UNITED STATES PATENT AND TRADEMARK OFFICE

APPLICATION NO.	FILING DATE	FIRST NAMED INVENTOR	ATTORNEY DOCKET NO.	CONFIRMATION NO.
10/580,379	02/13/2007	Raymond John Bacon	508-051.009	2557

Office Action Summary	Application No. 10/580,379	Applicant(s) BACON, RAYMOND JOHN	
	Examiner DANIEL R. SHEARER	Art Unit 3754

DETAILED ACTION

Fig. 2 of Brunet as annotated by examiner

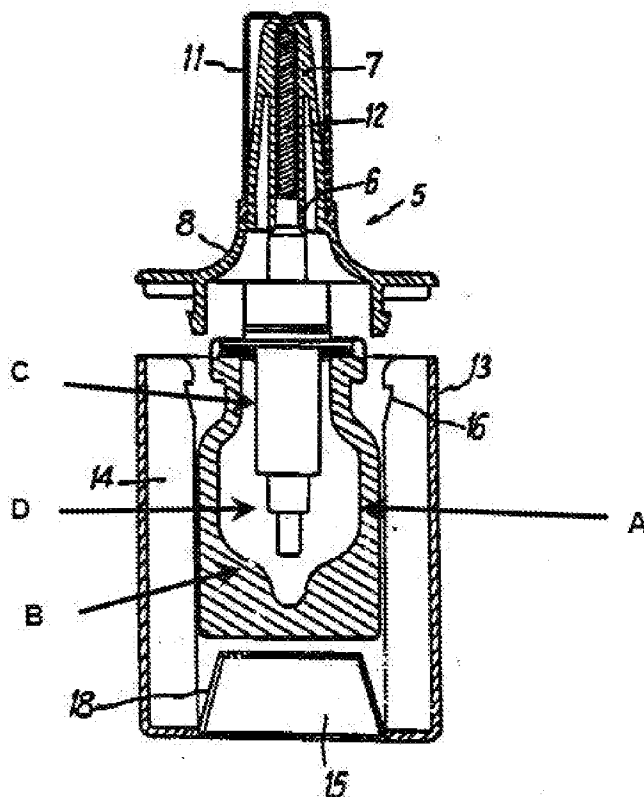
Brunet shows a dispenser for a gaseous, gas borne or droplet substance comprising a source (2) of the substance, wherein the substance comprises medicament and propellant (Col. 1, ll. 7-20) and the source comprises a reservoir (2) and a release valve (3). The reservoir comprises: a major portion (A in examiner annotated figure below) having a comparatively large cross-section of its substance space and a minor portion (B in examiner annotated figure below) in the form of a tapered tip having a comparatively small cross-section of its substance space and at the opposite end of the source from the release valve (Fig. 1).

Regarding claim 3, Brunet shows that the minor portion (B in examiner annotated figure below) of the reservoir has a progressively diminishing cross section whereby the rate of fall of the level of substance increases as it is further depleted (inherent effect from diminishing cross section).

Regarding claims 11, 13 and 14, Brunet shows that the reservoir is provided with a slug (C, D in examiner annotated figure below) which substantially reduces the cross-section thereof, includes a uniform cross section (C in examiner annotated figure below

has constant cross section) and is tapered (D in examiner annotated figure below tapers).
